Town & Country Planning Act 1990

Land North of Gardenia Close and Garden Square

Planning Inspectorate Ref: APP/X3540/W/19/3242636

Proof of Evidence

Figure 3: Extract from Site Layout Plan showing treatment along secondary route

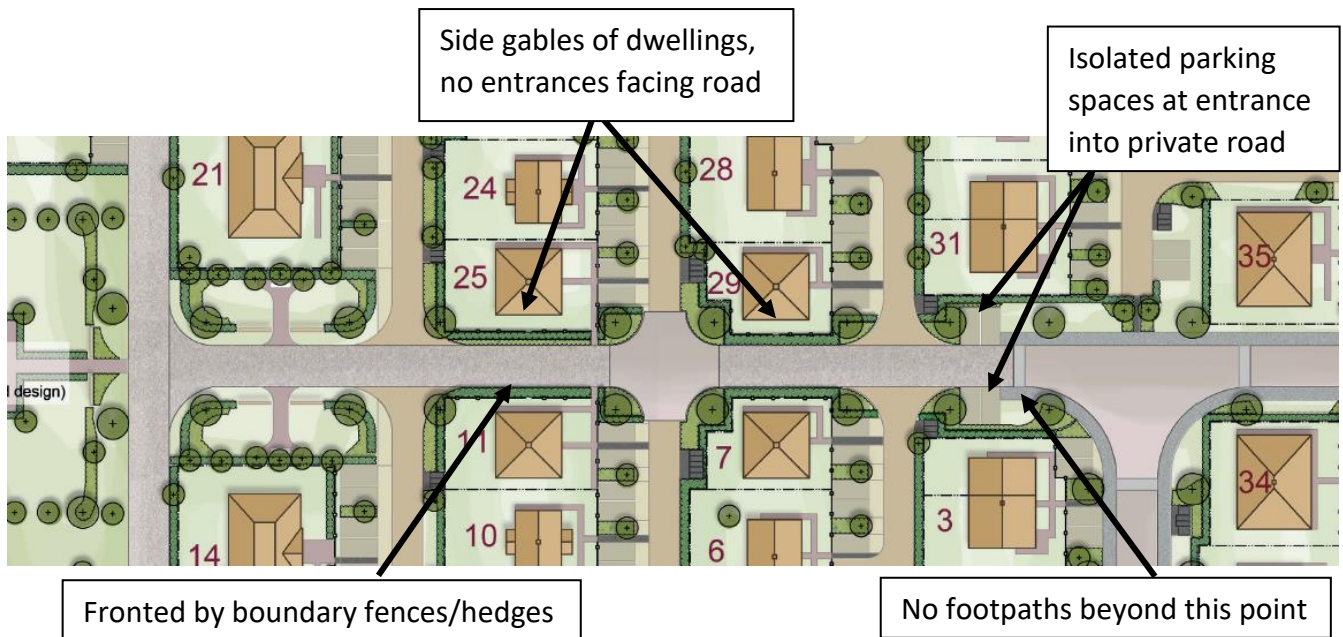
- 6.5 Further, it is noteworthy that the only differentiation in road treatment between the main route and the secondary route along the principal site axis is the use of footpaths either side of the main route. Otherwise, the main road is treated in a closely similar way to the axial secondary route – dwellings placed side on to it and edged with high fences and hedges.
- 6.6 The effect of the principal axial route being designed as a secondary route and similar in treatment to what is the designed main route is that the road layout will lack clarity in terms of its hierarchy of use.

Figure 5: Extract from Site Layout Plan to show the Tidy Road entrance to the site

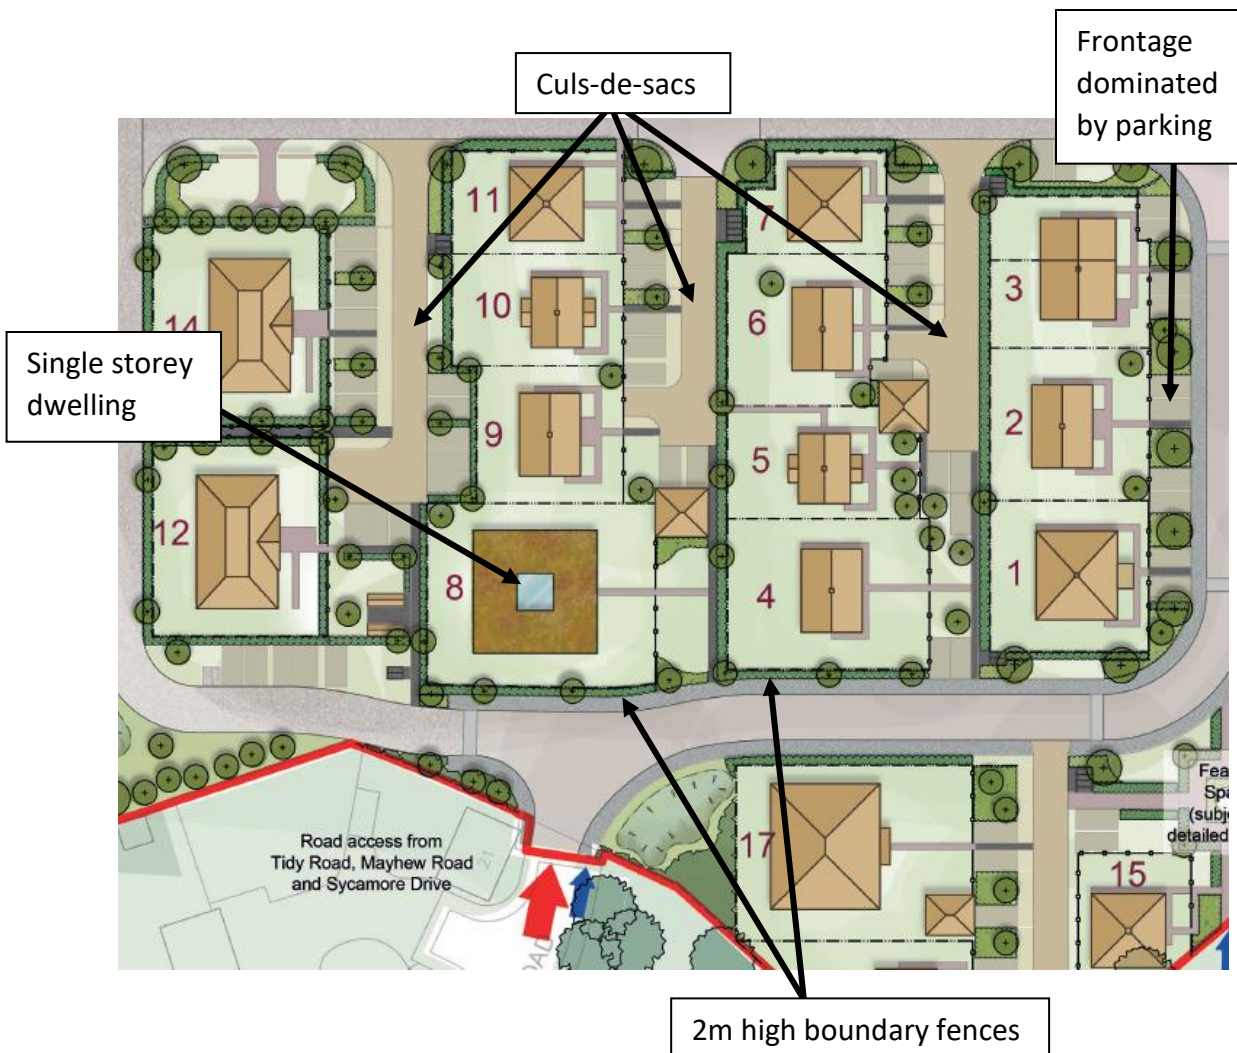
- 8.2 For example, the principal access into the appeal layout via Tidy Road (which provides pedestrian and vehicular access and is the primary interface with the existing community) is presented with a vista of a single storey dwelling hidden behind a 2m high close-boarded wooden fence and the back-ends of three culs-de-sac backing onto a primary arrival into the site. The effect of this signals the character of this public street i.e. unwelcoming and without positive visual appeal. Traversing this main route eastwards, it is possible to see that it is enclosed, not by front gardens and active dwelling frontages providing safe outlook, but primarily by side and rear elevations and high 2m boundaries. The resultant street character will be unwelcoming and of poor quality. Where plot no.s 1-3 do face directly onto this street, their frontage will be dominated by parked vehicles.

Figure 6: Extracts from the Site Layout Plan to show indeterminate spaces within the layout

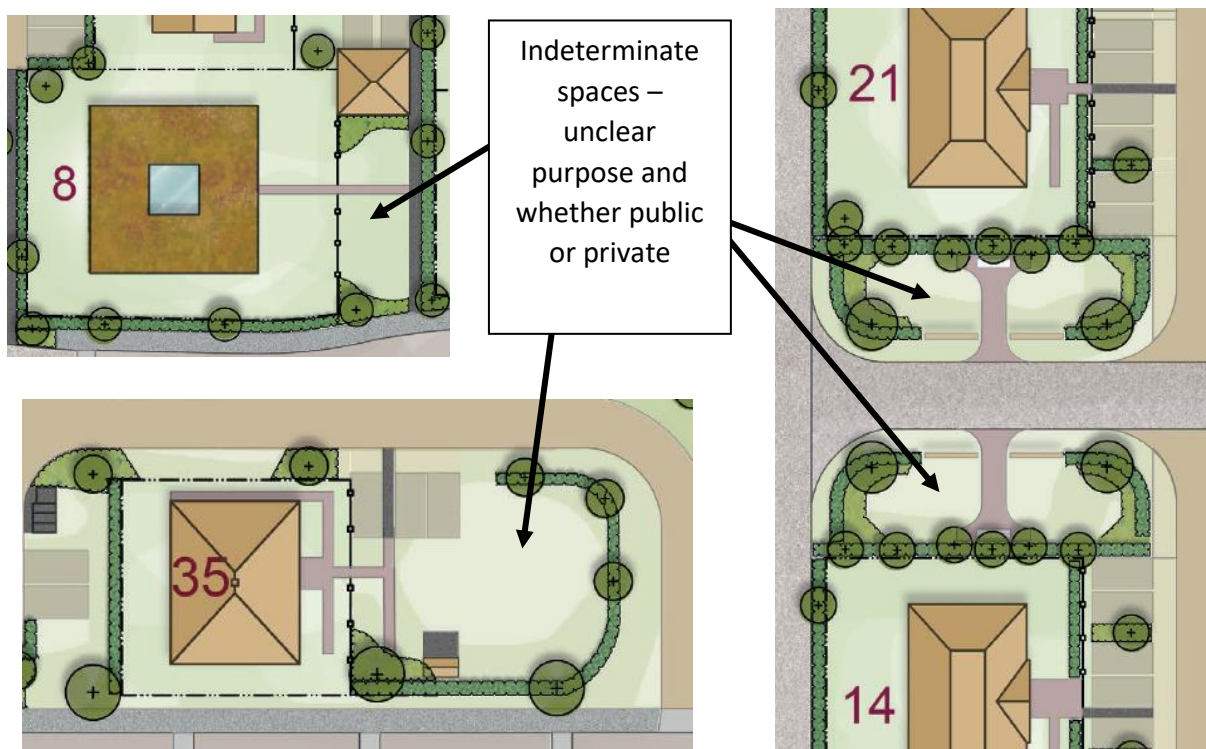
8.4 The layout is partly characterised by a quantity of enclosed spaces of indeterminate use that appear to be neither fully public nor fully private. These include to the immediate north of plot no. 14; to the immediate south of plot no. 21; to the immediate east of plot no. 8; opposite plot no.15; and to the immediate east of plot no. 35. Good space is useful space and where that is indeterminate, as in the appeal layout, it can add in to uncertainty about how to navigate and use the layout.

Figure 8: Extract from the Site Layout Plan showing the open space on the north-eastern side of the site

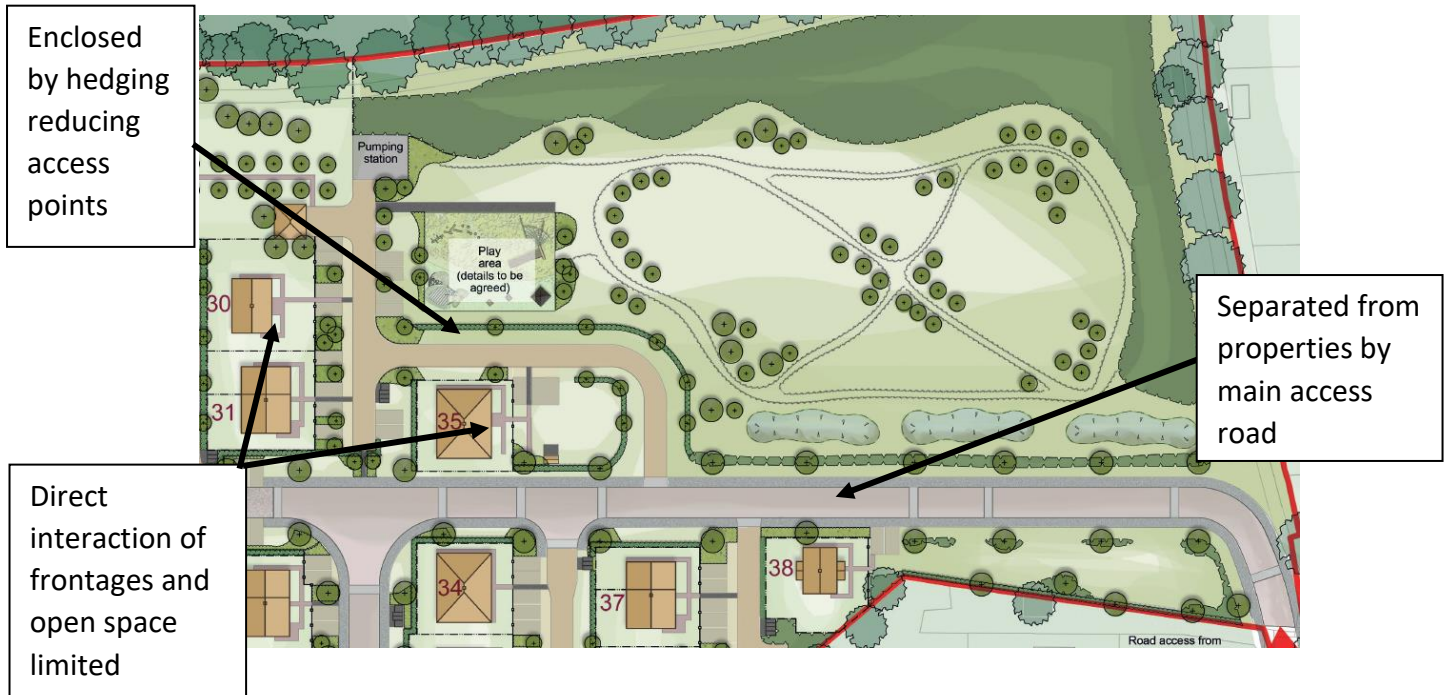
- 8.9 The position of open spaces within the layout is partly dictated by the desire to create a green buffer to the sewage treatment works to the north-east of the site which is understandable. This open space (that includes a play area), however, is largely edged by the main route along its southern boundary where it connects with the residential layout. The effect of this is to semi-detach it from surrounding properties and create barriers to its use, an effect exacerbated by the lack of active frontages that face onto this space that would provide passive supervision of it (excepting for plot no.35) and its enclosure by hedging. The opportunity to use this space for fronting dwellings onto it and thereby creating an attractive outlook has been ignored.

- 8.10 Both the north-eastern and western areas of public open space are not fully integrated into the layout due to barriers and a lack of overlooking. This is because the housing

and open spaces have not been designed together. The effect of this will be to discourage the safe use of the open spaces.
